CALIFORNIA COASTAL COMMISSION

December 21, 2000

**SUBJECT: STAFF RECOMMENDATION ON CITY OF SAN DIEGO MAJOR LOCAL
COASTAL PROGRAM AMENDMENT #4-2000 (CENTRE CITY—NORTH
EMBARCADERO OVERLAY DISTRICT)**

Proposed Centre City Planned District Boundary

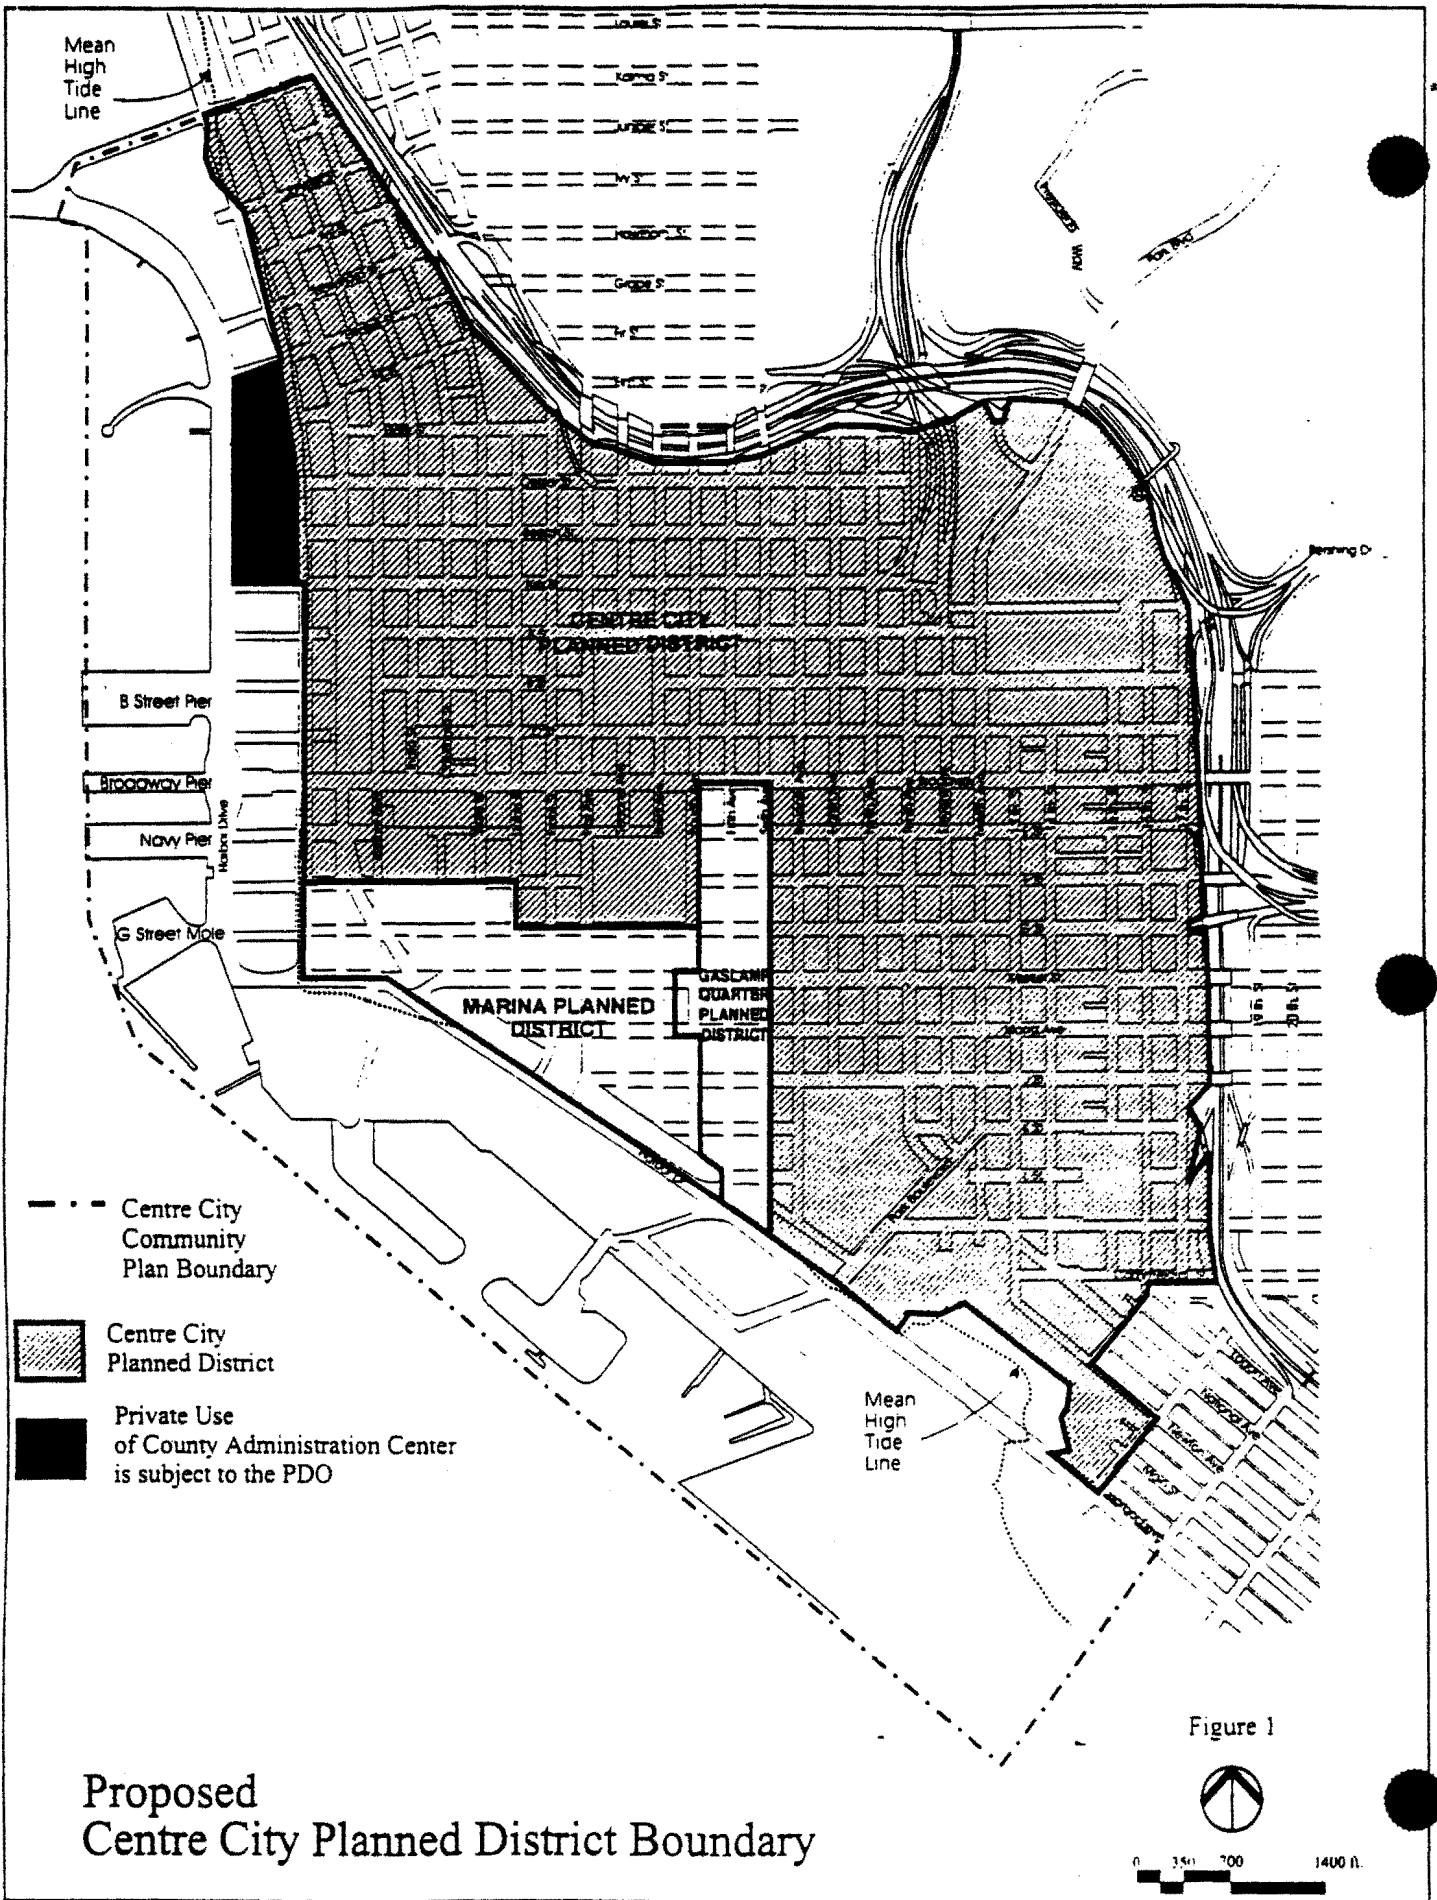
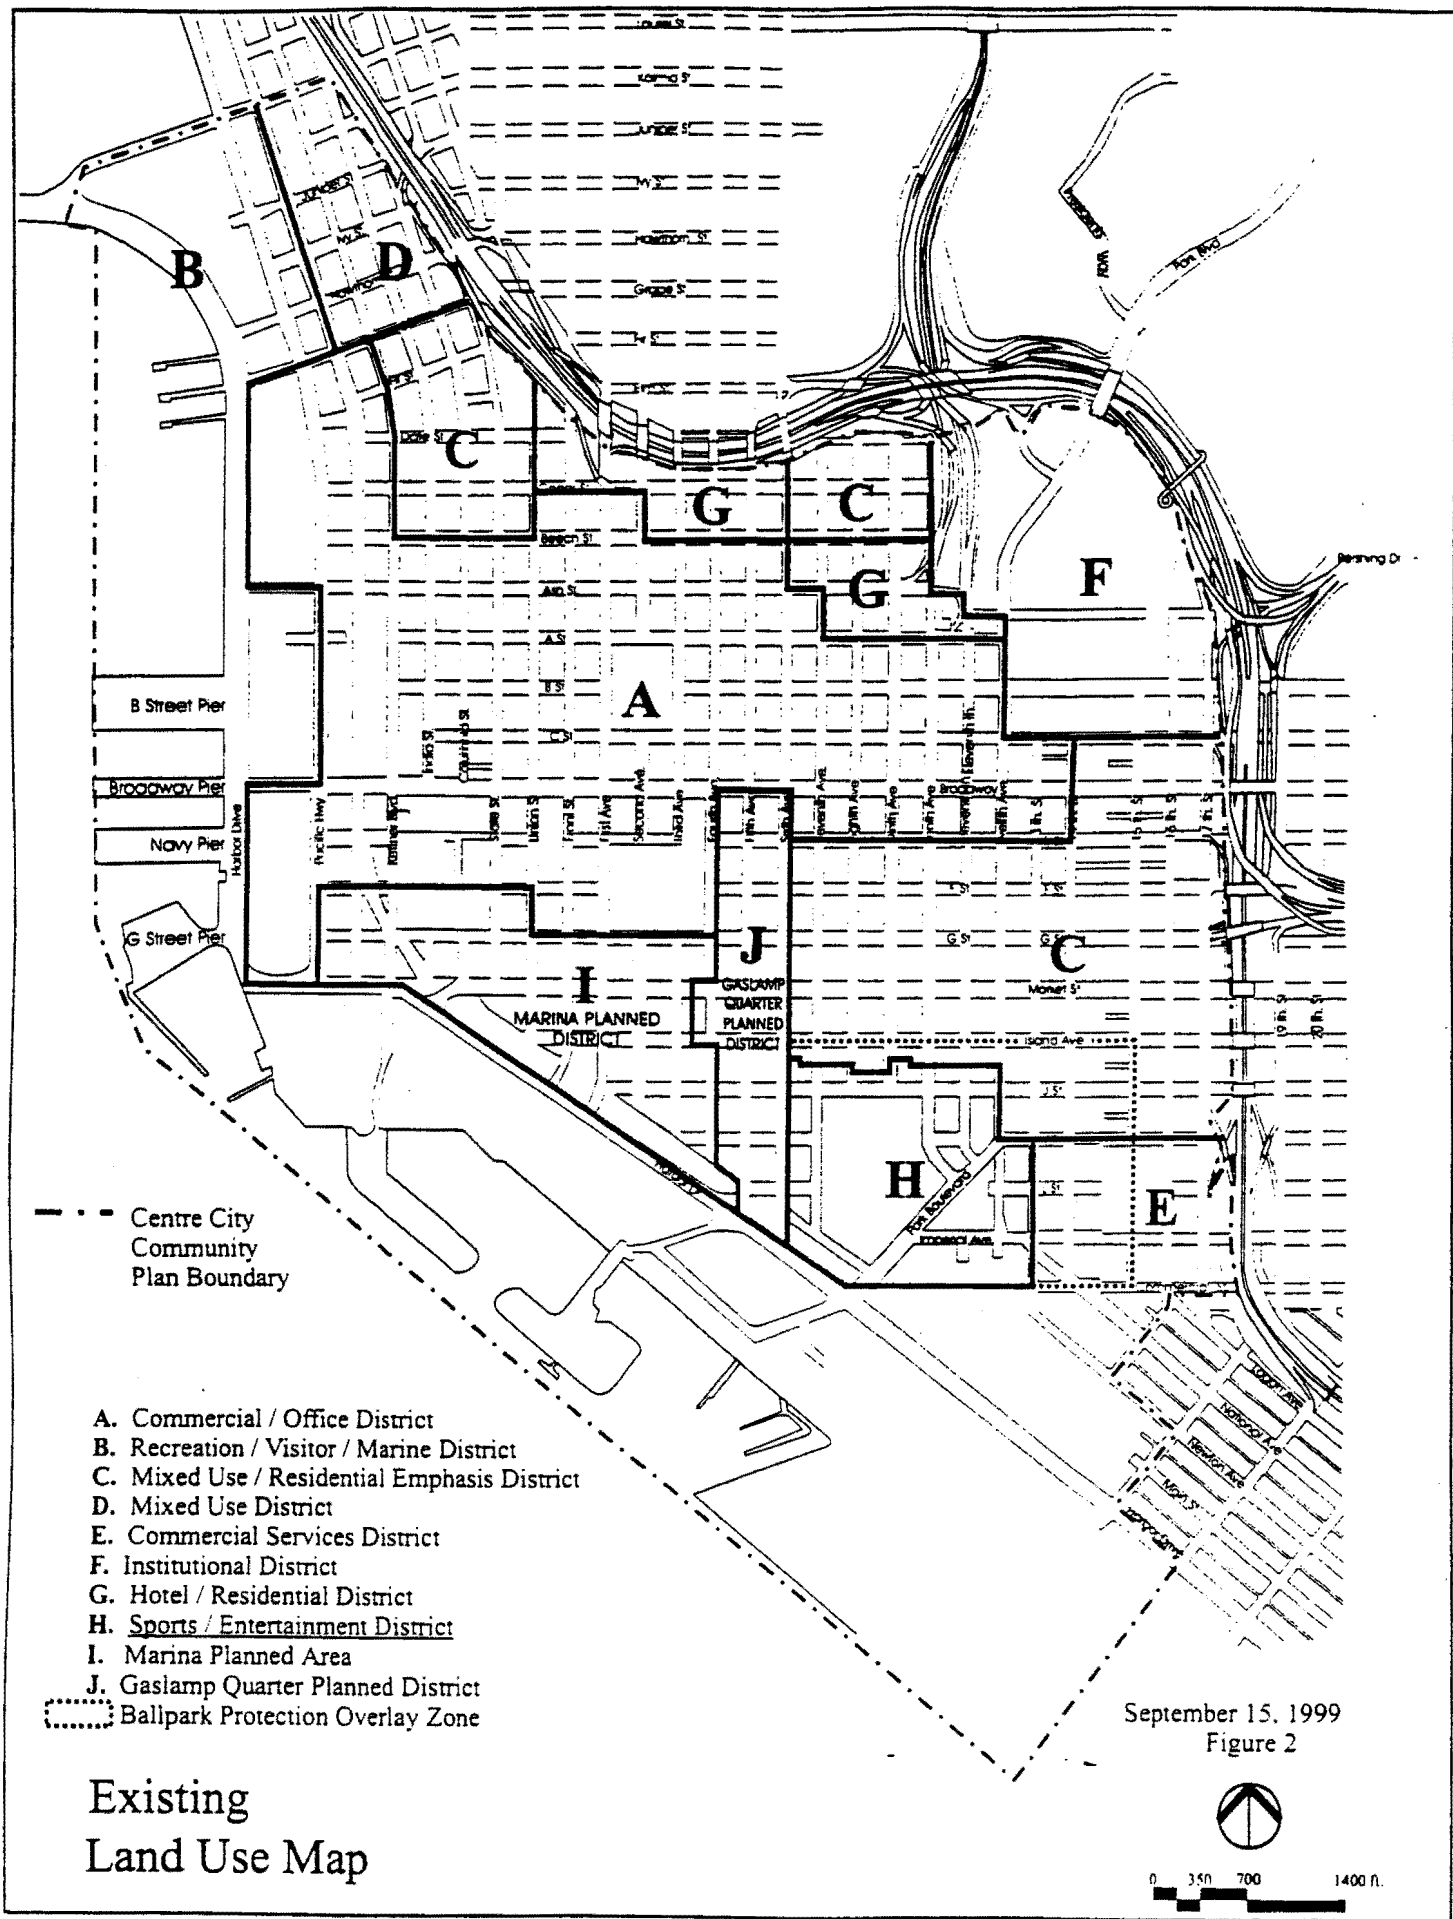
The proposed PDO contains two references to the standard of review for development at the County Administration Center that do not accurately reflect the status of the certified LCP. Both the proposed Section 103.1903 and Figure 1, Centre City Planned District Boundary in the PDO contain language implying that private development at the location of the County Administration Center would be subject to the provisions of the PDO. However, in January 1988, the Commission certified the Centre City/Pacific Highway Corridor segment of the City's Land Use Plan. At this time, the Commission deferred certification of the County Administration Center, finding that the zoning proposed for the area at the time (Central Business District), was not consistent with the certified Land Use Plan. The Commission also noted that there are jurisdictional questions raised about the City and County planning and regulatory roles on this site that support deferred action and further study. Thus, the area was excluded from the certified LCP, and remains in the Commission's jurisdiction, subject to the Chapter 3 policies of the Coastal Act, not the PDO. Therefore, the language in the proposed PDO amendment is not accurate and cannot adequately implement the certified Land Use Plan.

proposed text and Figure 1 of the PDO in order to correctly identify the County Administration Center as an area of deferred certification.

6. Figure 1, **Centre City Planned District Boundary**, the legend for the County Administration Center shall be revised as follows:
